August 29, 2016

PC 16-17

Site plan approval for a parcel in
the Yorktown Commons PD,
with companion major changes to
standards of the approved form-
based code.

INTER-DEPARTMENTAL REVIEW

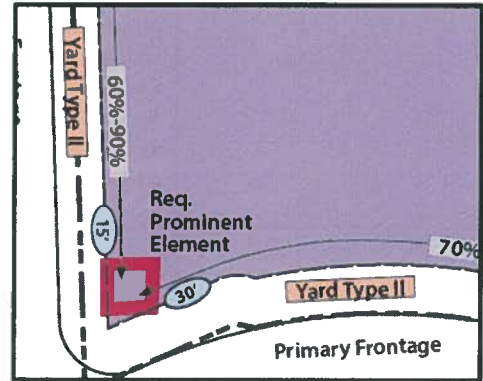
The petitioner requests a major change to the approved build-to line for the east side of the property in order to accommodate the development. One reason the petitioner offers for this request is that there is an irregular jog in the south property line of the parcel, which has impacted the positioning of the building on the site (see graphic in Part B below for depiction of this jog). The Design Guidelines did not reflect this irregularity in establishing the build-to lines.

Staff notes that there is a sanitary sewer line proposed for the east side of the subject property. The Village requires the building to maintain separation from the location of the sanitary sewer. The building has been shifted away from the property line to accommodate this requirement.

Upon review of the site plan, staff finds that the proposed major change in this build-to line will not significantly impact the final development in terms of its ability to meet the intent of the Design Guidelines and the objectives of the Yorktown Commons Planned Development. As demonstrated in the petitioner's response to standards for major changes in the Yorktown Commons Planned Development, the requested change will not create public health or safety concerns, nor will it impede the developer's ability to provide adequate public utilities and infrastructure improvements

or meet the overall intent of the planned development. The change will also address the issue of separation between the building and sanitary sewer line. Staff supports this major change.

FIGURE 24: Street Sections – Illustrative Typical Section of Grace Street

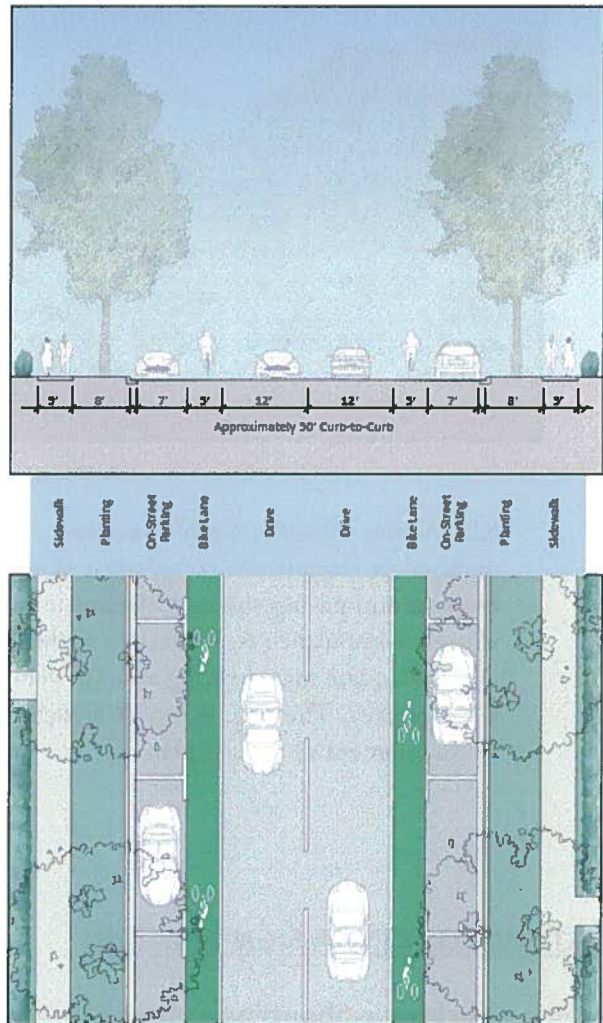
Section VII(J) of the Design Guidelines requires the Grace Street right-of-way between 22nd Street and the Yorktown ring road to be reconfigured to include on-street parking and bike lanes. Figure 24 from the Design Guidelines illustrates the required roadway configuration for Grace Street. This requirement reflects the 2016 Village-wide Bicycle and Pedestrian Master Plan, which identified the Grace Avenue right-of-way as a target area for bike and pedestrian improvements.

The Yorktown Commons Planned Development approval (PC 15-17C) stipulated that the required Grace Street ROW improvements would occur when either Parcel 1 or Parcel 4 developed. Accordingly, the petitioner for PC 16-17 has provided site plans showing the required parallel parking spaces and bike lane. The petitioner also may consider replacing existing cobra-style street lights with shorter residential-style street lamps, though this has yet to be finalized. The Community Development Department finds the proposed ROW improvements are consistent with the amenities required by the Design Guidelines. Final design of these ROW improvements will be subject to review and approval by the Public Works Department.
